Subject: Official Notice No. 172  
Reroofing of Sanitation Facility South Area 1  
Office/Storage, Garage and Salt Shed Buildings  
Also as Alternate Bid  
Window & Door Replacement of  
Sanitation Facility-South Area 1 Office Building  
2363 South 35<sup>th</sup> Street  
Milwaukee, Wisconsin  
For which bid will be received on  
Thursday, December 15, 2011 at 10:30 a.m.

Addendum No. 2

**ADDENDUM No. 2**  
**December 12, 2011**

Groth Design Group Project No.: 11.032.2

**AD-1 ROOF EDGE DETAIL - GARAGE**

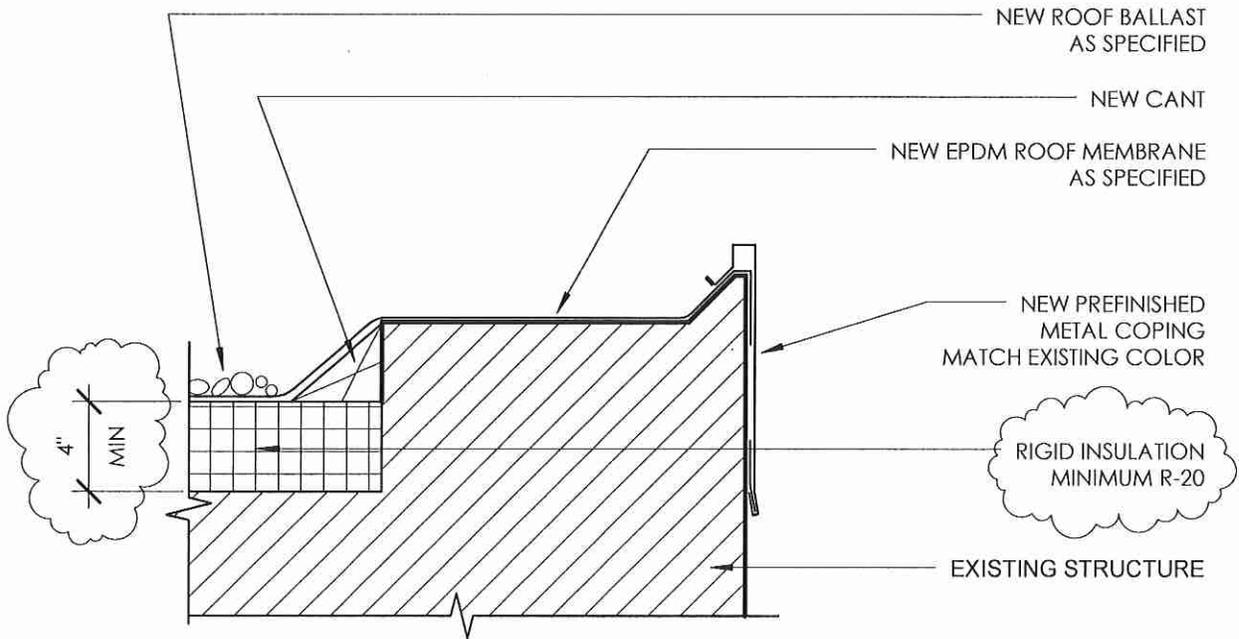
A. Sheet A7.1 ROOF PLAN

**Revision – Detail 4/A7.1:**

See attached supplemental detail drawing R-1.

NOTE: EXISTING ROOF DECK SLOPES, INSULATION SHOULD BE UNIFORM THICKNESS ACROSS ENTIRE ROOF.
